UNITED STATES
DEPARTMENT OF THE INTERIOR
BUREAU OF LAND MANAGEMENTNMOCD
HobbsFORM APPROVED
OMB NO. 1004-0137
Expires: January 31, 2018**SUNDRY NOTICES AND REPORTS ON WELLS**
*Do not use this form for proposals to drill or to re-enter an abandoned well. Use form 3160-3 (APD) for such proposals.***SUBMIT IN TRIPLICATE - Other instructions on page 2**

Revised Permit Information 1/17/18:

Well Name: Antietam 9 Fed Com No. 706H

Proposed Wellbore
Revised 1/17/18
API: 30-025-*****

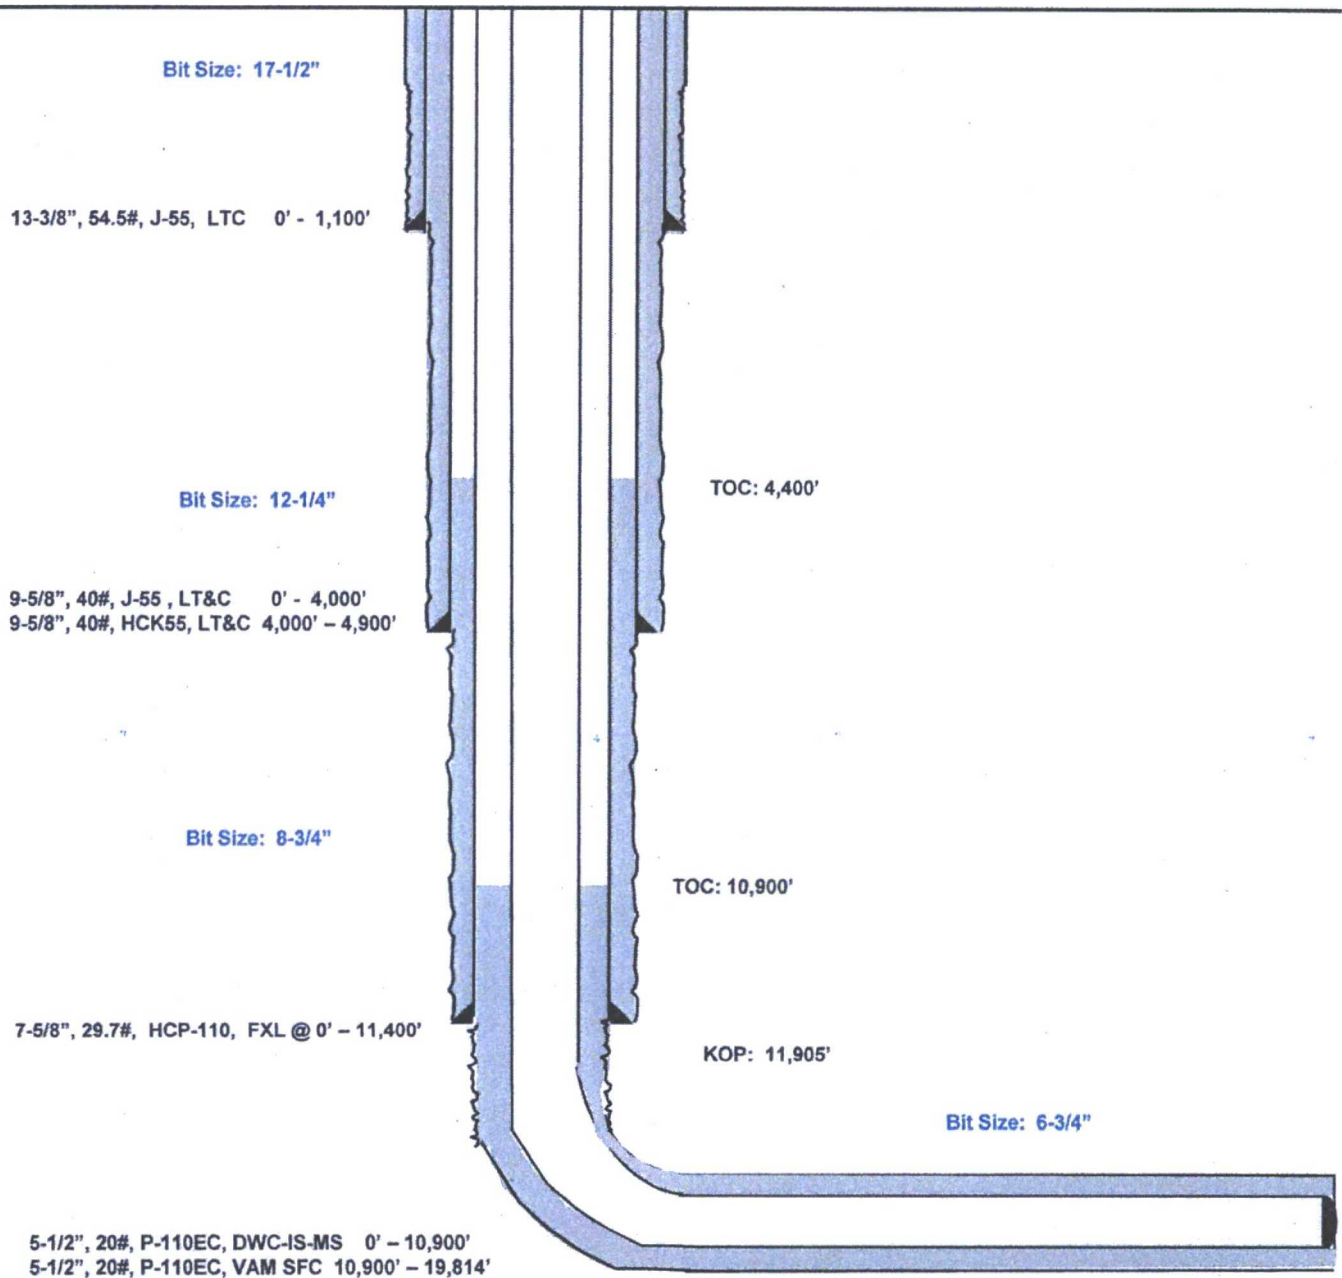
EOG Resources requests an amendment to our approved APD for this well to reflect a change in casing design as attached.

Change to a 4-string casing design.

Variance is requested for annular clearance of the 5-1/2" x 7-5/8" to the top of cement.

Hole Size	Interval	Csg OD	Weight	Grade	Conn	DF _{min} Collapse	DF _{min} Burst	DF _{min} Tension
17.5"	0 - 1,100'	13.375"	54.5#	J55	STC	1.125	1.25	1.60
12.25"	0-4,000'	9.625"	40#	J55	LTC	1.125	1.25	1.60
12.25"	4,000' - 4,900'	9.625"	40#	HCK55	LTC	1.125	1.25	1.60
8.75"	0 - 11,400'	7.625"	29.7#	HCP110	FXL	1.125	1.25	1.60
6.75"	0 - 10,900'	5.5"	20#	P110EC	DWC CIS MS	1.125	1.25	1.60
6.75"	0'-19,814'	5.5"	20#	P110EC	VAM SFC	1.125	1.25	1.60
